INVITATION FOR BID - HOLLISTON WASTEWATER SYSTEM UPGRADES – PHASE 1A
Addendum # 2, Issued: 07/06/2026

The Invitation for Bids (IFB) -Wastewater Treatment Plant Concrete Tank Installation dated July 1, 2026 and Holliston Linden St. Wastewater System Upgrades Phase 1A - Project Plans & Specifications, 3-6,000 Gallon Tanks & Force Main Specifications dated June 30, 2026 are hereby amended as follows:

Figure 1 Trench & Backfill Area

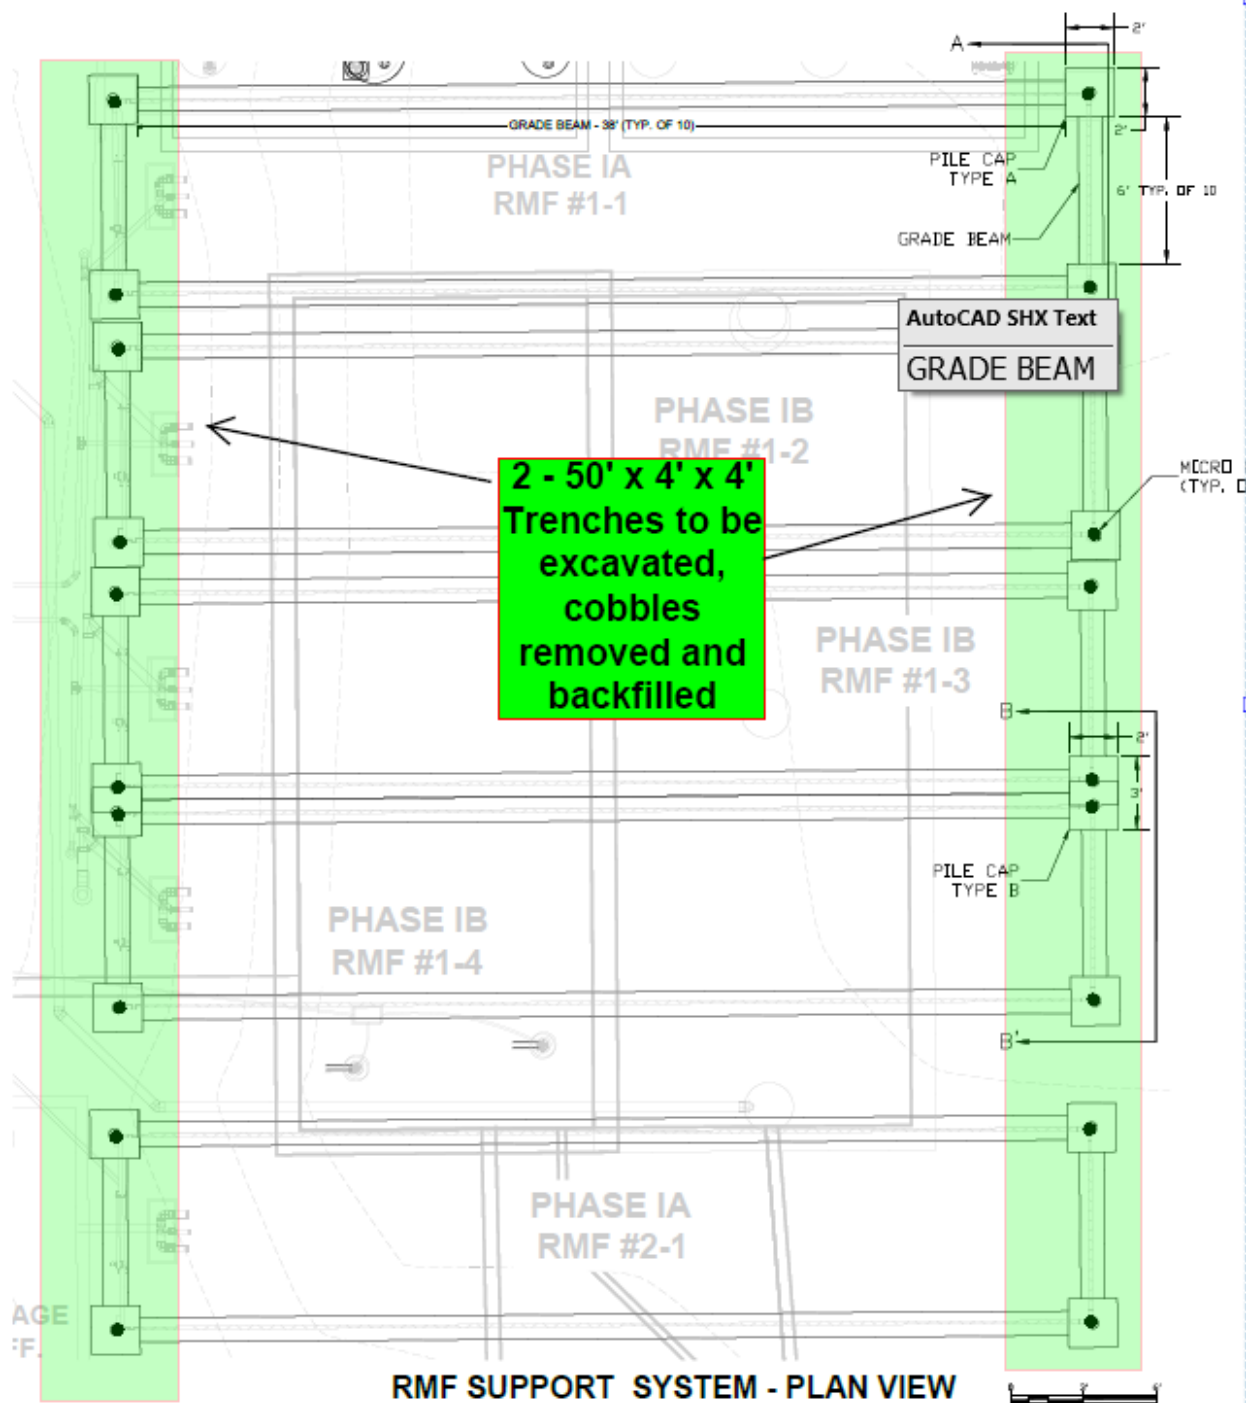
Insert

“ITEM 2.4 – Excavation of Two (2) Trenches Each 4 feet wide by 4 feet deep by 50 feet long, Remove Cobbles

The payment for Item 2.4 shall be based on the percent complete as proposed by the Contractor and approved by the Engineer. The work consists of excavation and backfill of Two (2) Trenches Each 4 feet wide by 4 feet deep x 50 Feet, remove cobbles and place them in nearby area as directed by the Engineer, all as shown on the pasted below Figure 1.”
